UNITED STATES PATENT AND TRADEMARK OFFICE

APPLICATION NO.	FILING DATE	FIRST NAMED INVENTOR	ATTORNEY DOCKET NO.	CONFIRMATION NO.
09 738,979	12 20 2000	Seiji Umemoto	Q62369	2654

Office Action Summary

DETAILED ACTION

Fig.3

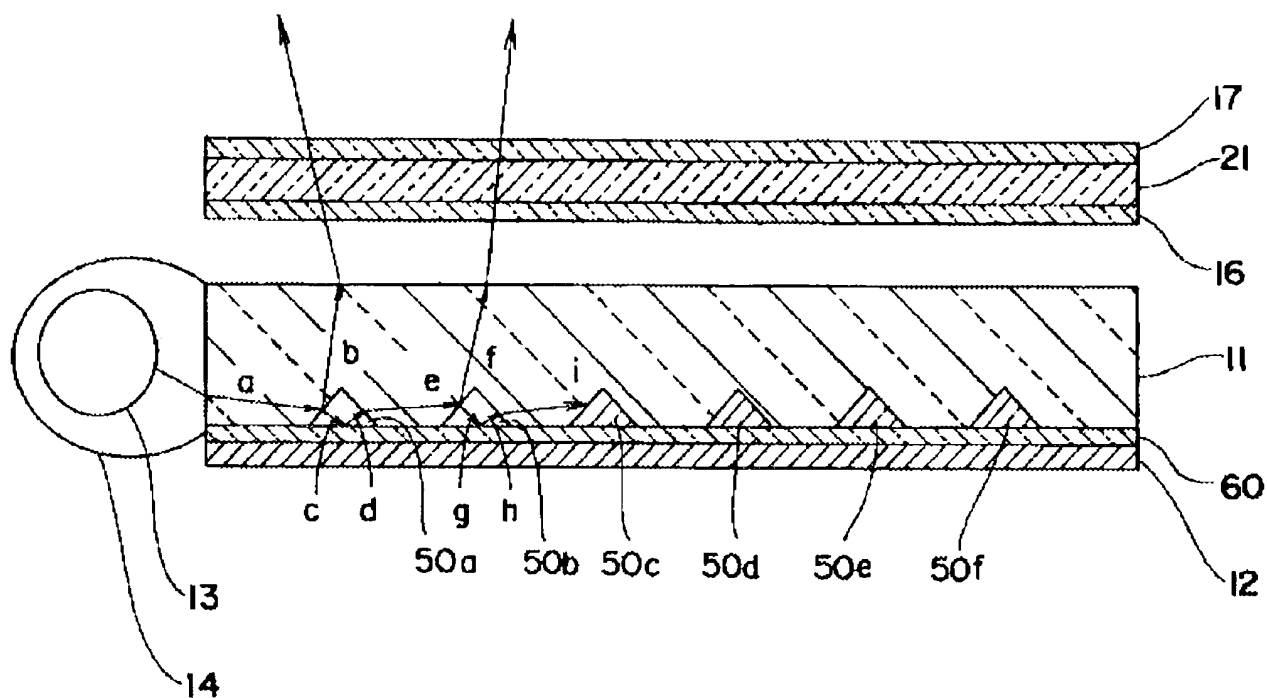
As to claims 1 and 15, Yuuki discloses in Figures 2, 3, and 4 (col. 5, line 19 through col. 8, line 52, especially col. 5, lines 45-55) a liquid-crystal display (LCD) device comprising: a transmission type liquid-crystal display panel, 21, including a liquid-crystal cell; a light source, 13, disposed on at least one side of said liquid-crystal display panel; and a light guide plate, 11, disposed on a back side, opposite to a visual side, of said liquid-crystal display panel and having a polarization rotating film, 60, with equilateral prism reflecting members, 50a through 50f, (Applicant's optical path

changing sheet with optical path changing slopes) by which incident light from said light source is reflected toward said visual side of said liquid-crystal display device (ray traces b and f).

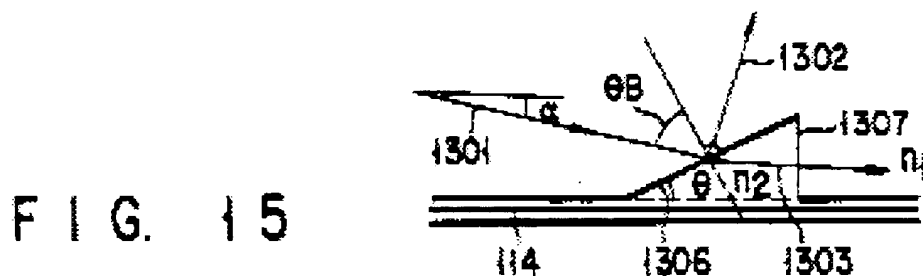
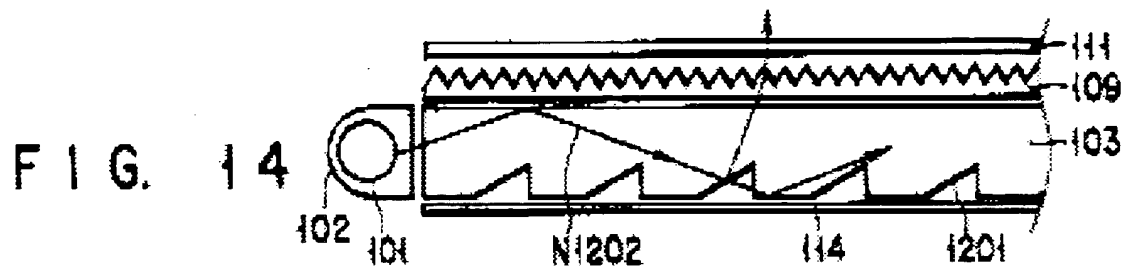
As to claims 1 and 15, Taira discloses in Figures 14 and 15 (embodiment 11, col. 13, line 50 through col. 15, line 16, especially col. 13, lines 60-67) a liquid-crystal display device (Title and Abstract) comprising: a transmission type liquid-crystal display panel including a liquid-crystal cell; a light source, 101, disposed on at least one side of said liquid-crystal display panel; and a light-guiding plate, 103, (Applicant's optical path changing sheet) disposed on a back side opposite to a visual side of said liquid-crystal display panel and having optical path changing slopes, 1201, by which incident light from said light source is reflected toward said visual side of said liquid-crystal display device (ray trace 1302).

FIG. 5B

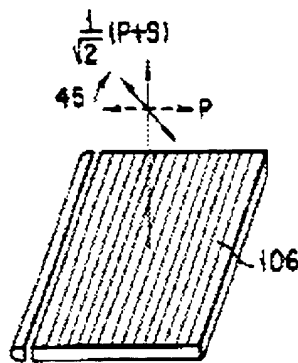
As to claim 10, Taira discloses in Figures 5B, 14, and 15 (embodiment 11, col. 13, line 50 through col. 15, line 16, especially col. 14, line 65 through col. 15, line 2) the liquid-crystal display device, wherein said prismatic concave portions are constituted by continuous grooves extended from one end of said sheet to the other end of said sheet in a ridgeline direction parallel to or inclined to a side surface of said liquid-crystal display panel on which said light source is disposed.

FIG. 10A

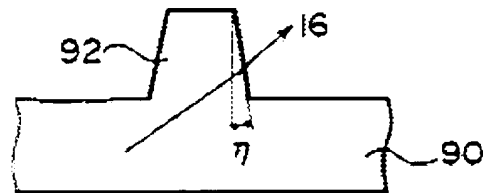
Miyashita teaches in Figure 10A the use of convex prismatic structures shaped substantially like a trapezoid in section to make manufacture by injection molding easier (col. 15, lines 58-67).

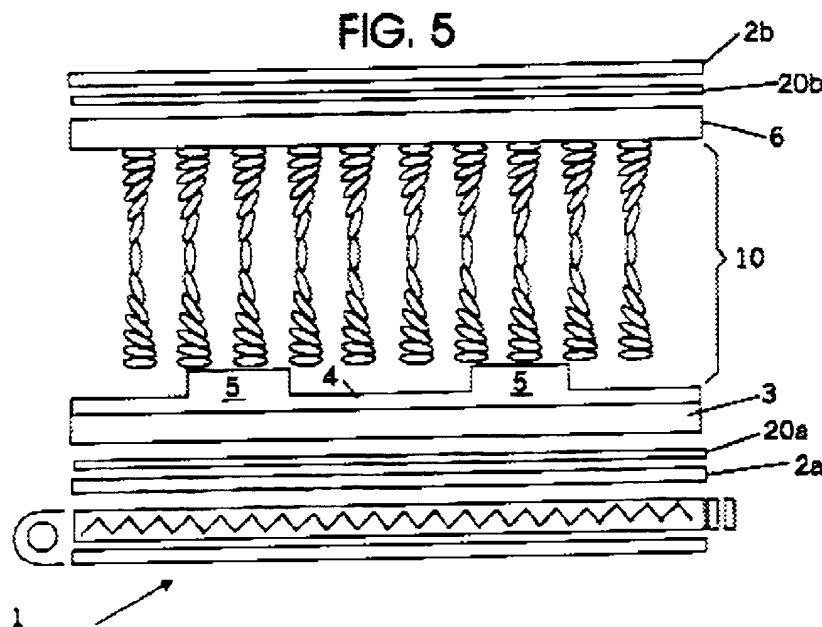
As to claim 12, Taira in view of Margerum discloses in Figures 14 and 15 (embodiment 11, col. 13, line 50 through col. 15, line 16, especially col. 14, lines 43-64) the A liquid-crystal display device, wherein each of said prismatic structures of said optical path changing sheet is constituted by a concave portion and having two or more optical path changing slopes facing said light source.
